Re: 29640-29640A
68 PRINCE PLACE - ROOF

Pages or sheets covered by this seal: I51688656 thru I51688656

Job	Truss	Truss Type	Qty	Ply	68 PRINCE PLACE - ROOF	151688656
29640-29640A	A6R	PIGGYBACK BASE	5	1	Job Reference (optional)

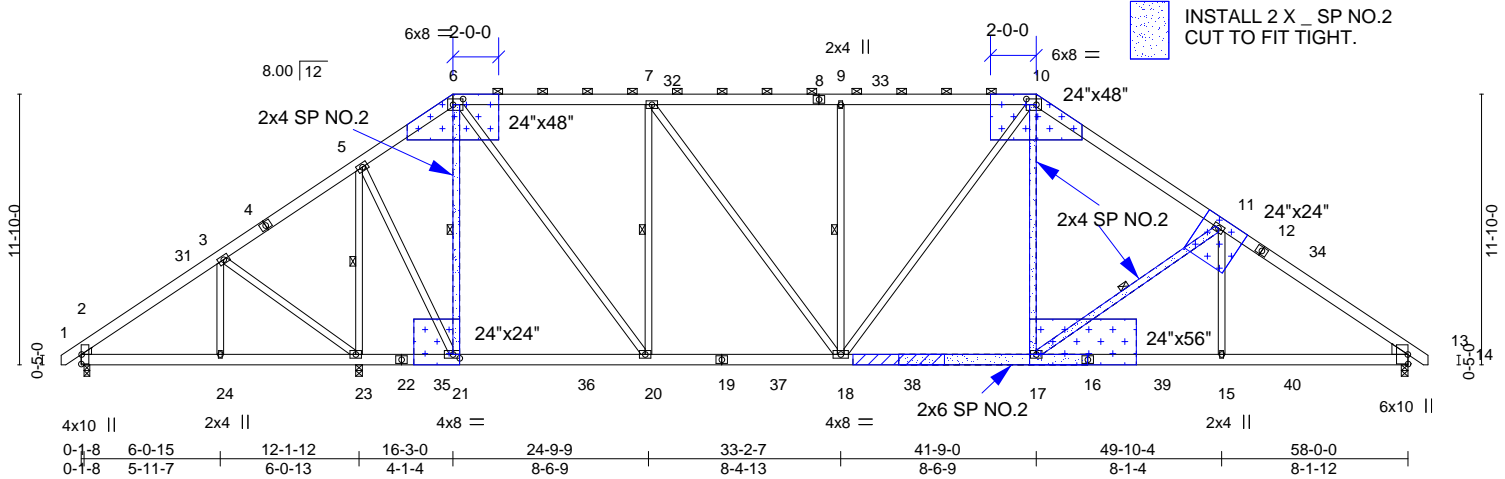
- NOTES-**
- 1) Repair Condition: web from joint 21 to joint 6 is a damaged section.
 - 2) Repair Condition: web from joint 17 to joint 10 is a damaged section.

- 3) Repair Condition: bottom chord has damaged section 8-3-0 long starting 0-0-2 to the left of joint 16.
 - 4) Repair Condition: web from joint 17 to joint 11 is a damaged section.

INSTALL 2 X SP NO.2 CUT TO FIT TIGHT.

ATTACH 1/2" PLYWOOD OR OSB GUSSET (15/32" RATED SHEATHING 32/16 EXP 1) TO EACH FACE OF TRUSS WITH (0.131" X 2.5" MIN.) NAILS PER THE FOLLOWING NAIL SCHEDULE: 2 X 3'S - 2 ROWS, 2 X 4'S - 3 ROWS, 2 X 6'S AND LARGER - 4 ROWS: SPACED @ 4" O.C. NAILS TO BE DRIVEN FROM BOTH FACES. STAGGER SPACING FROM FRONT TO BACK FACE FOR A NET 2" O.C. SPACING IN EACH COVERED TRUSS MEMBER. USE 2" MEMBER END DISTANCE.

APPLY 2 X 6 X 5' SP NO.2 SCAB(S) TO EACH FACE OF TRUSS CENTERED ON SPLICE AS SHOWN. ATTACH WITH (0.131" X 3") NAILS PER THE FOLLOWING NAIL SCHEDULE: 2 X 3'S - 1 ROW, 2 X 4'S - 2 ROWS, 2 X 6'S AND LARGER - 3 ROWS: SPACED @ 4" O.C. STAGGER NAIL SPACING FROM FRONT FACE AND BACK FACE FOR A NET 2" O.C. SPACING IN THE TRUSS. USE 2" MEMBER END DISTANCE.
